Product Change Notification

PCN #:	AM20260703-1
Issue Date:	July 3 rd , 2026
Products series affected:	AM3T-LPZ series
Product list:	All part numbers from the AM3T-LPZ series.
Effective Date:	All part numbers from the AM3T-LPZ series shipping from Aimtec as of the issue date of this PCN.
Description of change:	All part numbers listed in the above product list from the AM3T-LPZ series have their input current, maximum capacitive load, efficiency, tested isolation voltage, voltage tolerance, line regulation, load regulation, ripple & noise, transient recovery time, transient recovery deviation, switching frequency, over current protection, over voltage protection, humidity, weight, derating, typical application circuit and recommended EMC circuit updated as per the details provided in the following ANNEX 1.
Reason for change:	This change has been implemented due to the EOL of critical raw materials.
Customer Impact:	Certain customers may be impacted by these changes in the specifications. Aimtec recommends reviewing the datasheet and testing samples as necessary.

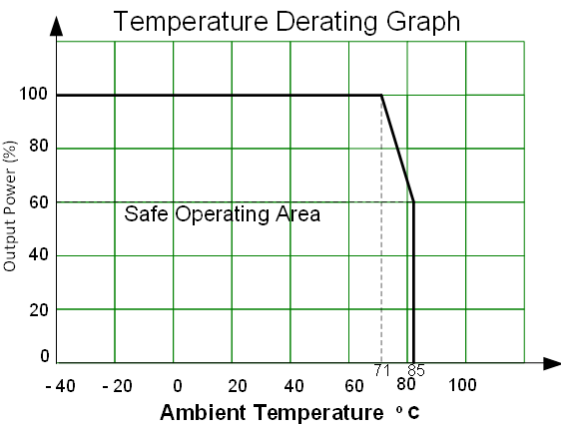
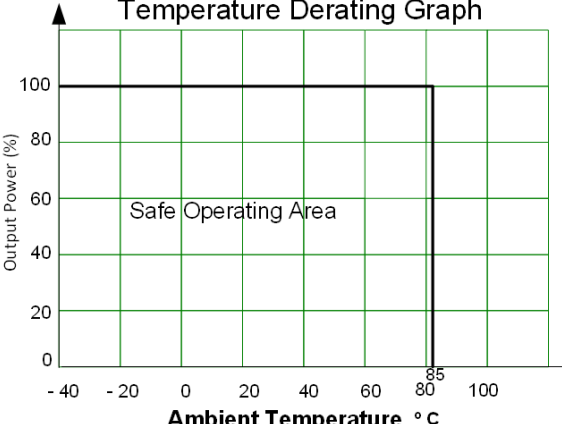
Derating	Derating 	Derating 																																																																	
Typical application circuit	Typical Application Circuit <table><tr><th>Vin</th><th>Co1</th><th>Co2</th><th>Co3</th></tr><tr><td>3.3, 5, 6V</td><td>47µF, 16V</td><td>10µF, 50V</td><td>0.1µF, 16V</td></tr><tr><td>9, 12, 15V</td><td>47µF, 25V</td><td>10µF, 50V</td><td>0.1µF, 25V</td></tr><tr><td>18, 24, 28V</td><td>47µF, 50V</td><td>10µF, 50V</td><td>0.1µF, 50V</td></tr></table> For dual output models, the recommended output values apply to each output.	Vin	Co1	Co2	Co3	3.3, 5, 6V	47µF, 16V	10µF, 50V	0.1µF, 16V	9, 12, 15V	47µF, 25V	10µF, 50V	0.1µF, 25V	18, 24, 28V	47µF, 50V	10µF, 50V	0.1µF, 50V	Typical application circuit <table><tr><th>Vin</th><th>Cin</th><th>Cout</th></tr><tr><td>5VDC</td><td>100µF</td><td></td></tr><tr><td>12VDC</td><td>100µF</td><td></td></tr><tr><td>24VDC</td><td>10-47µF</td><td>10µF</td></tr><tr><td>48VDC</td><td>10-47µF</td><td></td></tr></table>	Vin	Cin	Cout	5VDC	100µF		12VDC	100µF		24VDC	10-47µF	10µF	48VDC	10-47µF

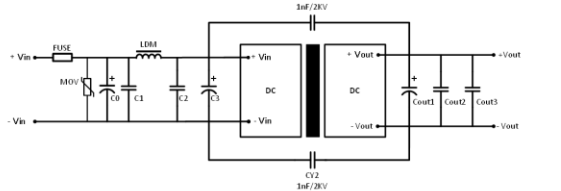
Vin	Co1	Co2	Co3																																																																
3.3, 5, 6V	47µF, 16V	10µF, 50V	0.1µF, 16V																																																																
9, 12, 15V	47µF, 25V	10µF, 50V	0.1µF, 25V																																																																
18, 24, 28V	47µF, 50V	10µF, 50V	0.1µF, 50V																																																																
Vin	Cin	Cout																																																																	
5VDC	100µF																																																																		
12VDC	100µF																																																																		
24VDC	10-47µF	10µF																																																																	
48VDC	10-47µF																																																																		
Recommended EMC circuit	Recommended EMC Circuit <table><tr><th>Component</th><th>5Vin</th><th>12Vin</th><th>24Vin</th><th>48Vin</th></tr><tr><td>MOV</td><td>~</td><td>14D270K</td><td>200470K</td><td>14D101K</td></tr><tr><td>Co, C3</td><td>680µF, 25V</td><td>680µF, 25V</td><td>330µF, 50V</td><td>330µF, 100V</td></tr><tr><td>C1, C2</td><td>4.7µF, 50V</td><td>4.7µF, 50V</td><td>4.7µF, 50V</td><td>4.7µF, 100V</td></tr><tr><td>Co1, Co2, Co3</td><td colspan="4">Refer to Typical Application Circuit</td></tr><tr><td>LDM</td><td>12µH</td><td>12µH</td><td>12µH</td><td>12µH</td></tr></table> FUSE : Choose according to actual input current	Component	5Vin	12Vin	24Vin	48Vin	MOV	~	14D270K	200470K	14D101K	Co, C3	680µF, 25V	680µF, 25V	330µF, 50V	330µF, 100V	C1, C2	4.7µF, 50V	4.7µF, 50V	4.7µF, 50V	4.7µF, 100V	Co1, Co2, Co3	Refer to Typical Application Circuit				LDM	12µH	12µH	12µH	12µH	EMC (CLASS B) Compliance Circuit <table><tr><th>Model</th><th>C1 & C2</th><th>C3</th><th>Cout</th><th>LDM</th><th>MOV</th><th>CY1</th></tr><tr><td>5Vin</td><td>4.7µF/50V</td><td>1000µF/16V</td><td></td><td></td><td>-</td><td></td></tr><tr><td>12Vin</td><td>4.7µF/50V</td><td>1000µF/25V</td><td></td><td></td><td>14D330K</td><td></td></tr><tr><td>24Vin</td><td>4.7µF/50V</td><td>330µF/50V</td><td></td><td></td><td>200470K</td><td></td></tr><tr><td>48Vin</td><td>4.7µF/100V</td><td>330µF/100V</td><td></td><td></td><td>14D101K</td><td>1nF/2KV</td></tr></table> FUSE : Choose according to actual input current	Model	C1 & C2	C3	Cout	LDM	MOV	CY1	5Vin	4.7µF/50V	1000µF/16V			-		12Vin	4.7µF/50V	1000µF/25V			14D330K		24Vin	4.7µF/50V	330µF/50V			200470K		48Vin	4.7µF/100V	330µF/100V			14D101K	1nF/2KV

Component	5Vin	12Vin	24Vin	48Vin																																																															
MOV	~	14D270K	200470K	14D101K																																																															
Co, C3	680µF, 25V	680µF, 25V	330µF, 50V	330µF, 100V																																																															
C1, C2	4.7µF, 50V	4.7µF, 50V	4.7µF, 50V	4.7µF, 100V																																																															
Co1, Co2, Co3	Refer to Typical Application Circuit																																																																		
LDM	12µH	12µH	12µH	12µH																																																															
Model	C1 & C2	C3	Cout	LDM	MOV	CY1																																																													
5Vin	4.7µF/50V	1000µF/16V			-																																																														
12Vin	4.7µF/50V	1000µF/25V			14D330K																																																														
24Vin	4.7µF/50V	330µF/50V			200470K

48Vin	4.7µF/100V	330µF/100V			14D101K	1nF/2KV
